SUNDRY NOTICES AND REPORTS ON WELLS
Do not use this form for proposals to drill or to re-enter an abandoned well. Use form 3160-3 (APD) for such proposals.

1. Type of Well <input checked="" type="checkbox"/> Oil Well <input type="checkbox"/> Gas Well <input type="checkbox"/> Other		8. Well Name and No. EXXON "8" FEDERAL 1
2. Name of Operator COG OPERATING, LLC		9. API Well No. 30-015-25894
3a. Address 600 W. ILLINOIS MIDLAND, TX 79701		10. Field and Pool or Exploratory Area WILLOW LAKE; BONE SPRING
3b. Phone No. (include area code) Ph: 432-580-7161		11. County or Parish, State EDDY CO COUNTY, NM
4. Location of Well (Footage, Sec., T., R., M., or Survey Description) Sec 8 T25S R29E 660FNL 860FEL 32.150123 N Lat, 104.000839 W Lon

Author:	MRM (7/2017)	
Well Name	Exxon 8 Federal	Well No. #1
Field	SE Willow Lake	API #: 30-015-25894
County	Eddy	Prop #: 15464
State	New Mexico	Zone: Bone Spring
Spud Date	3/30/1988	660 FNL & 860 FEL
GL	2,934'	Sec 08 T25S R29E
KB

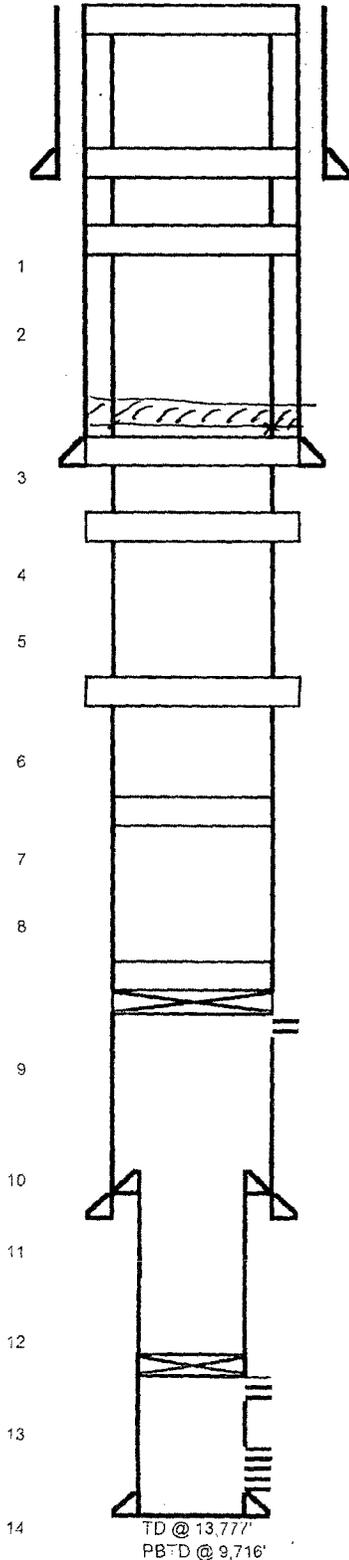
7. Perf & Sqz 75 sx cmt @ 687-~~587~~⁴⁵⁰ WOC & Tag. (20" Shoe)

6. Perf & Sqz 75 sx cmt @ 900-800'. *Not Reg-*

4. Perf & Sqz 75 sx cmt @ 3800-~~3700~~³⁶⁶⁰. (Cherry Canyon)

2. Spot 55 sx cmt @ 6700-~~6550~~⁶⁵³⁰. (Bone Springs)

8350'. *8320*
8,542'-8,601' (2nd Bone Spring) 13 holes - 05/17/1994 acidized with 1,250 gal and frac'd with 80,000 lbs

450 B/salt
500 T/salt
2647 B/salt
3660 WOC Tag
6530 Class C
65 Class H
